Product Change Notification: PCN-24-229857

Product Description: (Text limited to 120 characters)
Ampseal Plug Assembly Product Drawing Clarification

General Description of Changes
The Industrial and Commercial Transportation business unit of TE Connectivity is making a minor drawing change to clarify the verbiage of the note that calls out the material of the housings for the Ampseal Plug Assembly for the product drawing(s) listed below.
Other attachments:
[2293782_Redline](#)
[2371886_Redline](#)

APVD: G. BROWN	DATE: 29JUN2015	NAME: PLUG ASSEMBLY, AMPSEAL FAMILY DRAWING
CHK: D. STRAUSSER	DATE: 29JUN2015	SIZE: A1
DWN: A. MARTIN	DATE: 11JUN2015	SCALE: 4:1
PRODUCT SPEC: 108-1329	APPLICATION SPEC: 114-16016	SHEET 1 OF 2
WEIGHT: -	CUSTOMER DRAWING	REV: E2

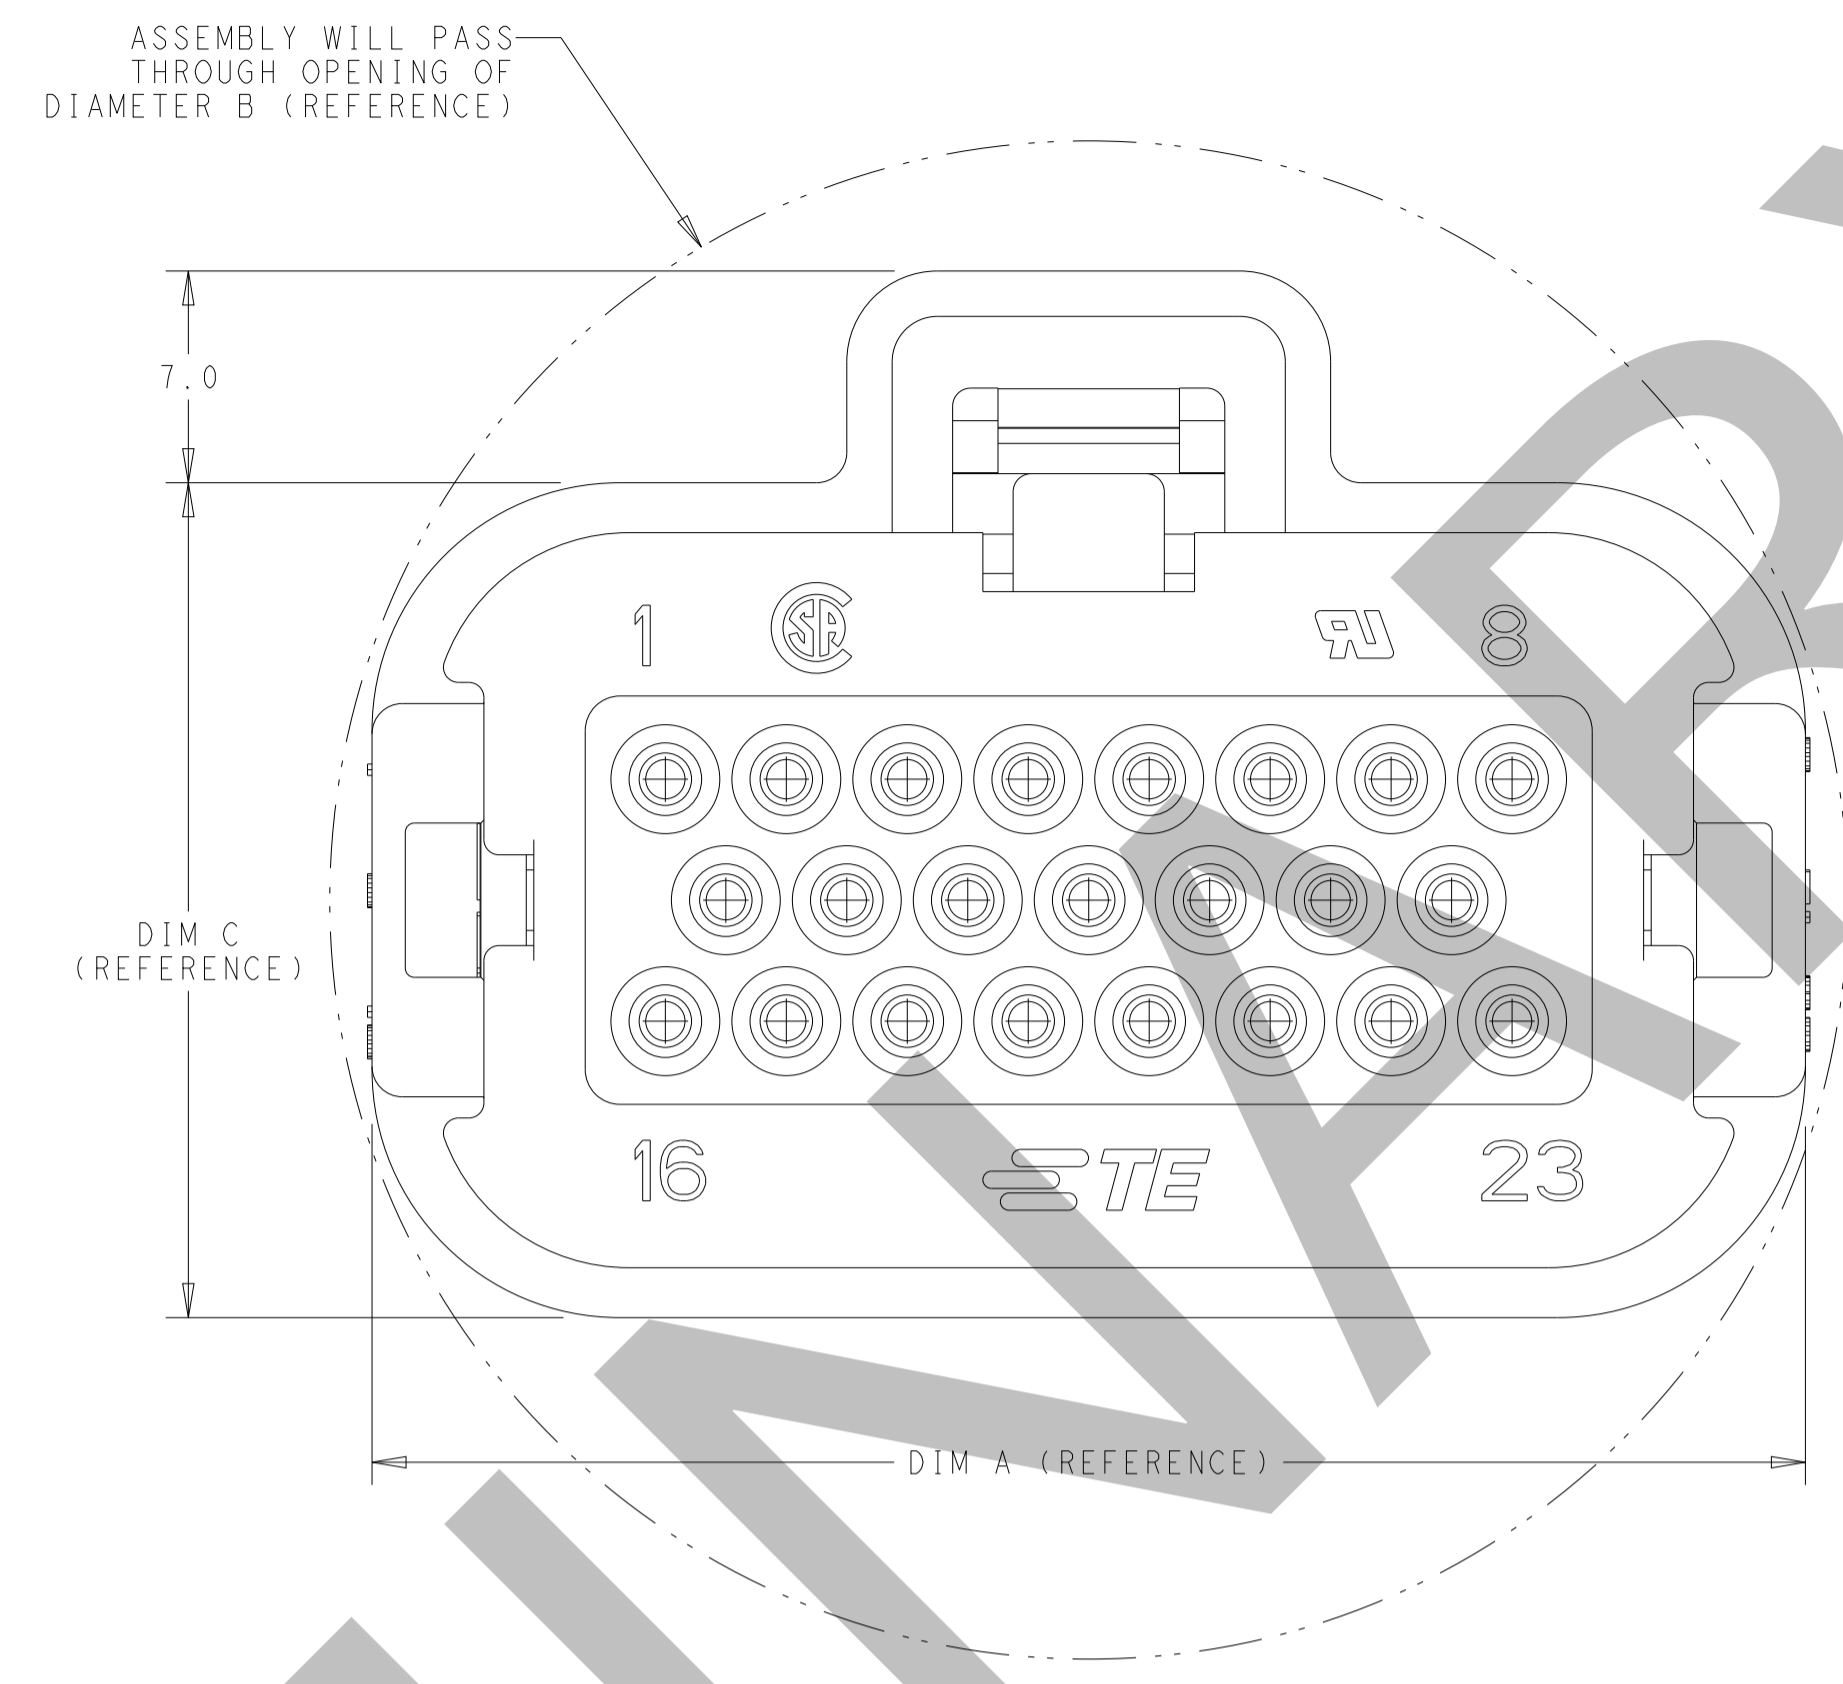
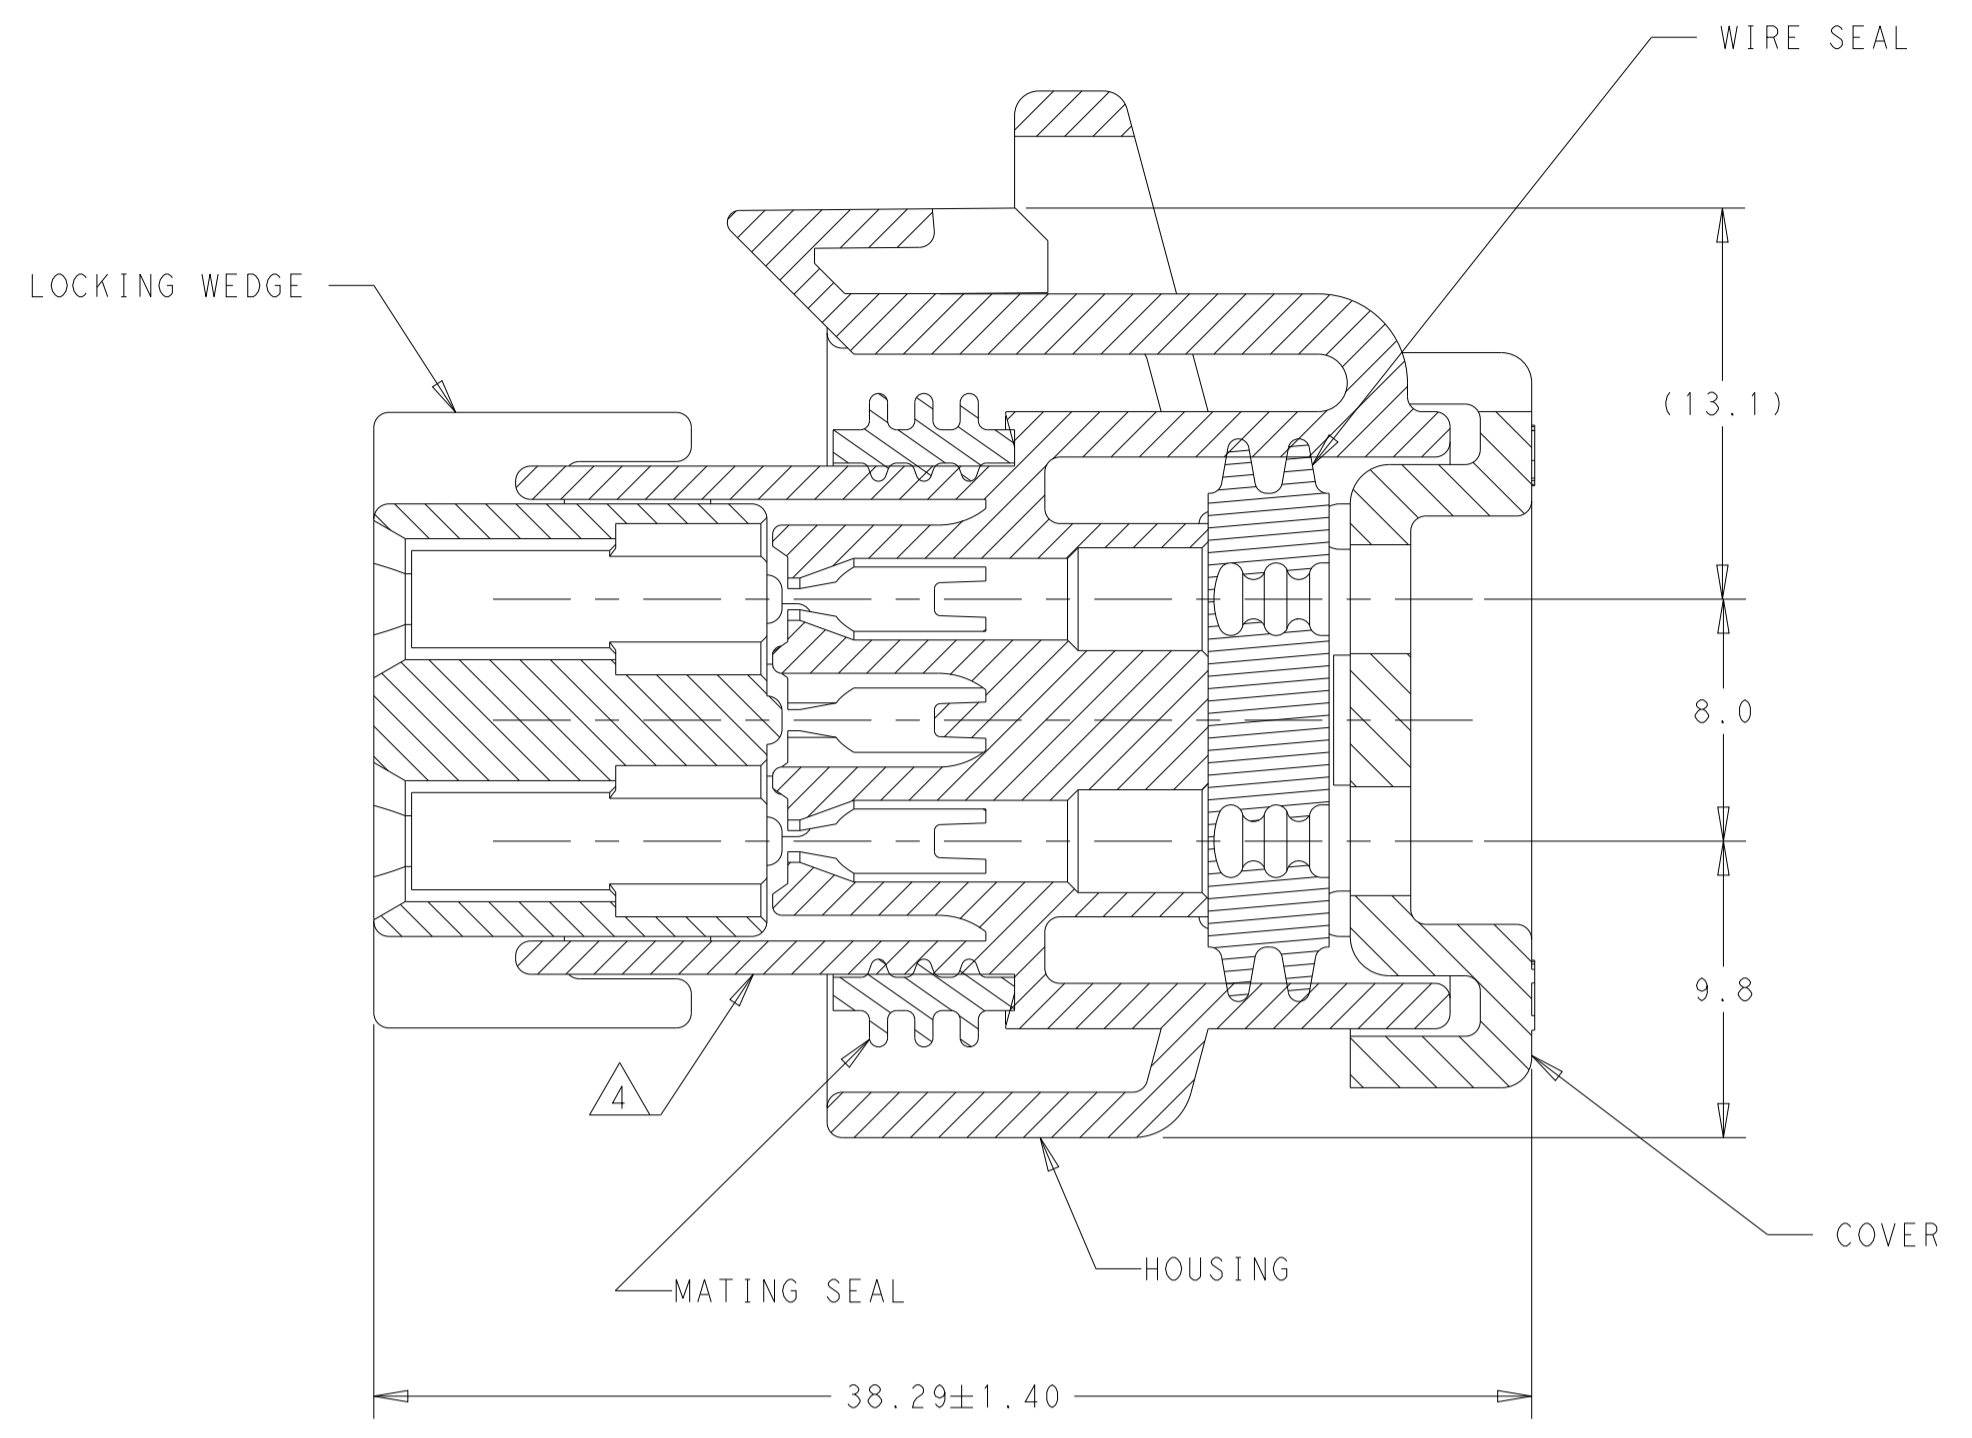
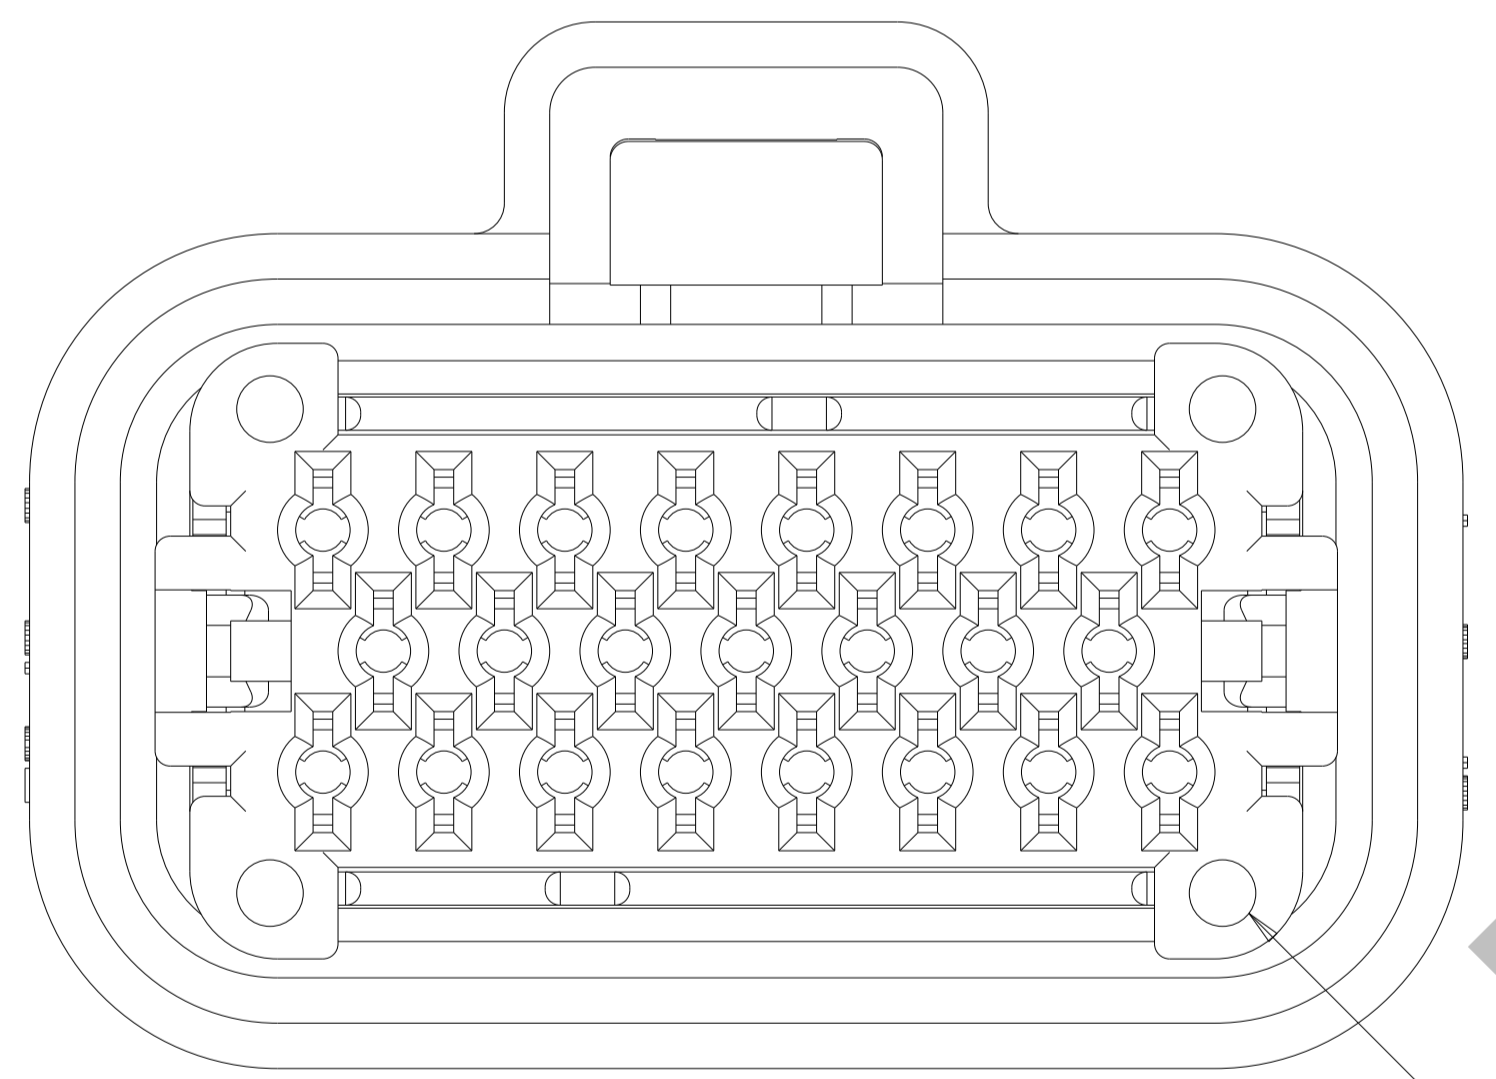
- MATERIAL: HOUSING - UL94V-0 PBT + PC
 LOCKING WEDGE - UL94V-0 PBT, RED
 COVER - UL94V-0 PBT, BLACK
 MATING SEAL - SILICONE
 WIRE SEAL - SILICONE
- HOUSING COLORS ARE MECHANICALLY KEYPED TO MATE WITH IDENTICALLY COLORED HEADER ASSEMBLIES
- PLUG USES REELED TERMINAL 770520 OR LOOSE PIECE TERMINAL 770854. SEE TABLE 1 FOR WIRE RANGE
- DATE CODE ON THIS SURFACE. USES 5 DIGIT CODE: FIRST 2 DIGITS = YEAR, SECOND 2 DIGITS = WEEK, LAST DIGIT = DAY
- CIRCUITS 3, 7, 16, 17, 21, 22 BLOCKED
- OPTIONAL VOID CORING ON 35 POSITION PLUG ASSEMBLY 776164
